## **Safety Advisory Notice**

To all affected users of the SIEMENS systems  
Luminos Agile Max, Luminos dRF Max, LUMINOS  
Lotus Max with display ceiling suspension and  
Multitom Rax with display wall suspension

## **Re: Potential risk of unintentional lowering of the support arm for display ceiling suspension / display wall suspension**

Figure 1 Display ceiling suspension with ceiling tube circled

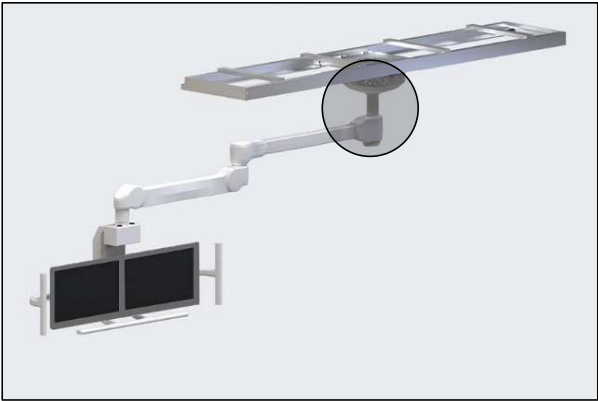
Please visually inspect the mounting screw on the ceiling tube (Figure 1) or wall tube (Figure 2) of the display suspension as far as this is possible from the ground.

If the mounting screw is missing, or if the screw head protrudes or is broken, discontinue use of the system immediately. Please inform the Siemens Healthineers customer service. Furthermore, if the display ceiling/wall suspension has lowered, discontinue use of the system immediately and inform customer service of the issue.

Figure 4 Incorrect: Mounting screw missing and/or lowered support arm

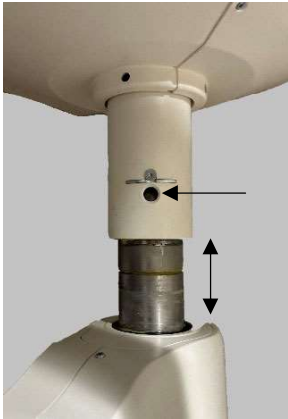
Exemplary illustration of mounting screw and tube attachment on the display ceiling suspension showing the correct (figure 3) versus incorrect (figure 4) tube attachment:

In case the visual inspection of the mounting screw does not show any abnormalities, you can continue to use the system. Nevertheless, until the system has been checked by Siemens Healthineers customer service with the planned field action, we recommend:

- not to swivel the support arm of the display ceiling/wall suspension to the mechanical limit with great force and
- to ensure that there is no one under the display ceiling/wall suspension when positioning the displays.
